CITY OF ALBUQUERQUE

September 3, 2020

**Re: Academy Dental Center
6421 Holly Ave NE
30-Day Temporary Certificate of Occupancy
Transportation Development Final Inspection
Engineer's/Architect's Stamp dated 4-3-20 (C18D038A)
Certification dated 8-24-20**

Site Plan
C1.0

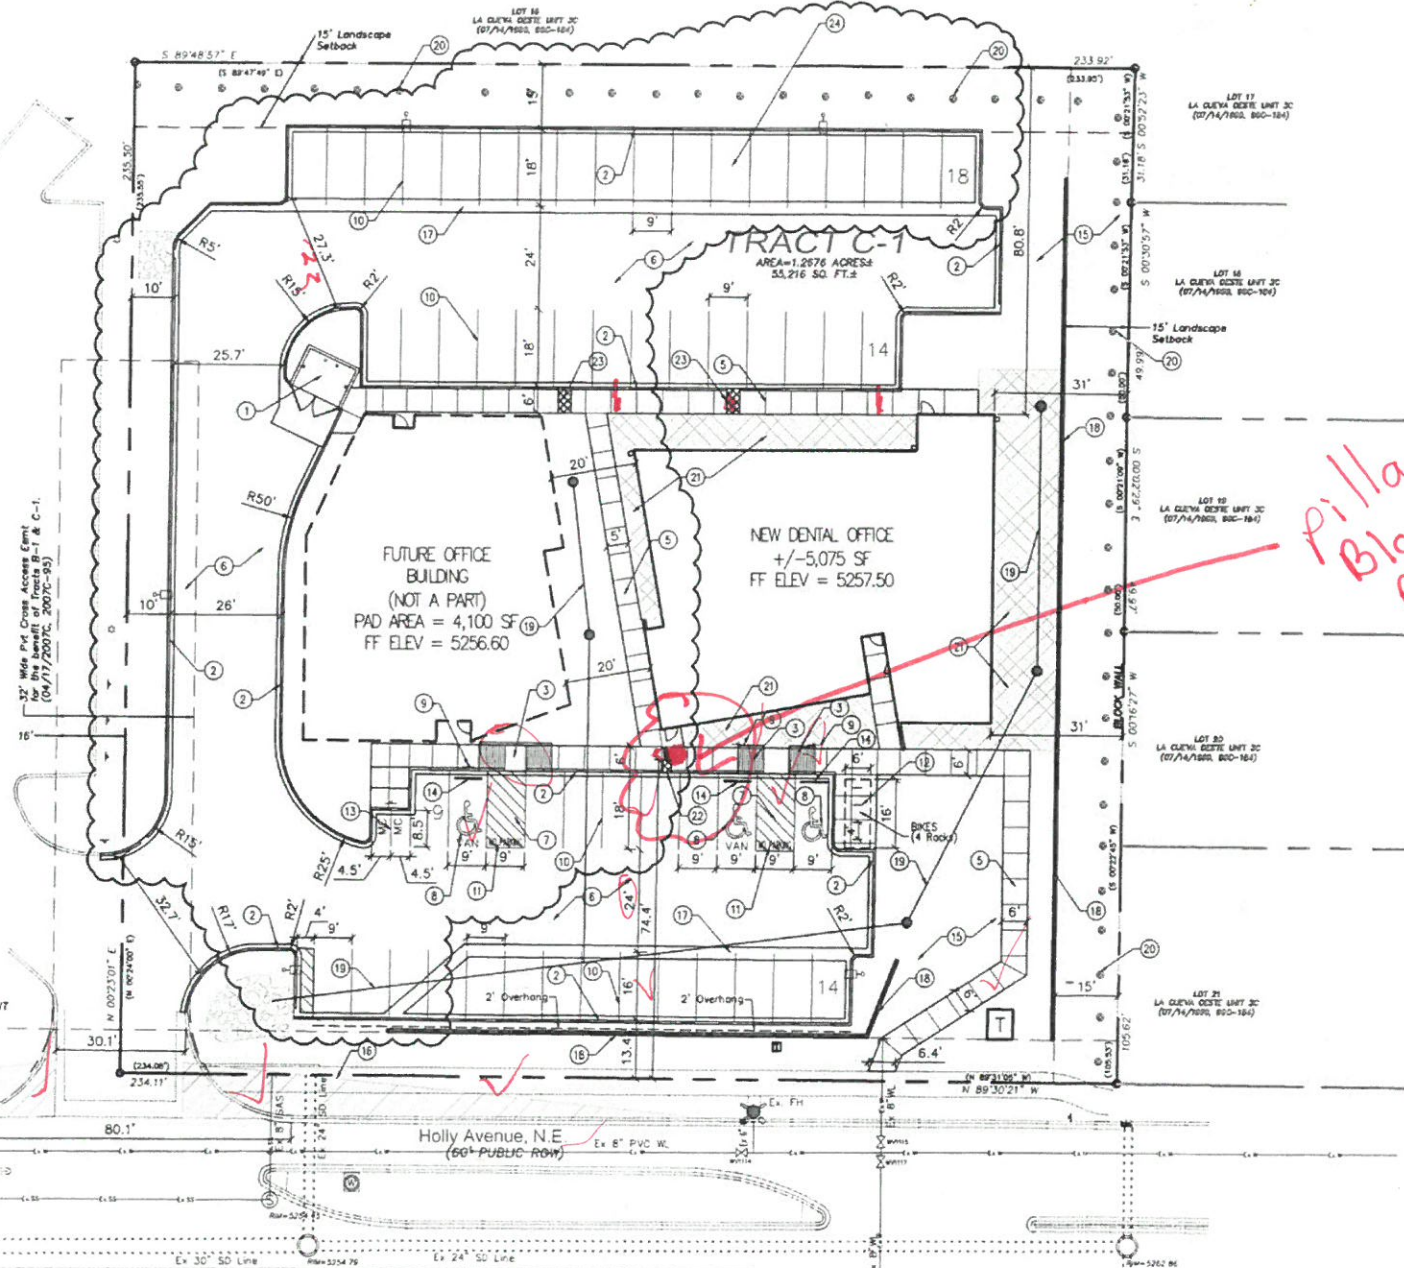
- Please add top plates to sidewalk culverts.

THE FOLLOWING ITEMS NEED TO BE CORRECTED PRIOR TO PERMANENT CERTIFICATE OF OCCUPANCY (PERM CO).
- THE STEEL PLATES FOR THE SIDEWALK CULVERTS NEED TO BE INSTALLED.
- THE PIN HOLES FOR THE TRASH ENCLOSURE DOORS NEED TO BE DRILLED.
- BIKE RACKS NEED TO BE INSTALLED ONTO THE CONCRETE PAD.
